Proposal for Supplement 3 to the 01 Series of Amendments to UN Regulation No. 150 (Uniform provisions concerning the approval of retro-reflective devices and markings for powerdriven vehicles and their trailers)

The text reproduced below was prepared by the expert from The Netherlands on behalf of the IWVTA IWG to delete the Unique Identifier (UI) marking provisions. The modifications to the existing text are marked in bold for new and strikethrough for deleted characters.

~~FIGURE I — UNIQUE IDENTIFIER (UI)~~

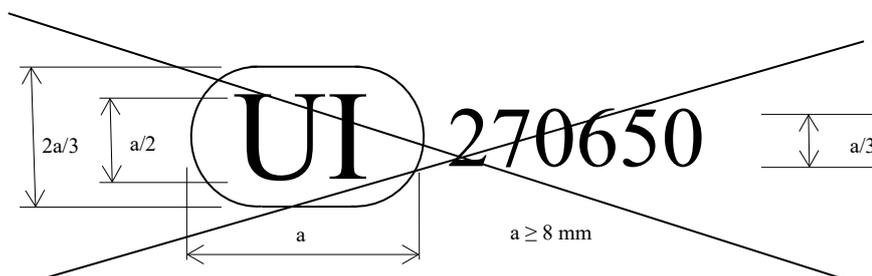
~~3.3.3.1. The approval marking as defined in paragraph 3.3.2. may be replaced by the Unique Identifier, if available. The Unique Identifier mark shall follow the format in the example shown below:~~

~~The above Unique Identifier marked on the retro reflective device shows that the type concerned has been approved and that the relevant information on that type approval can be accessed on the UN secure internet database by using 270650 as the Unique Identifier.~~

Paragraphs 3.3.4. (former) to 3.3.6., renumber as paragraphs 3.3.3. to 3.3.5.
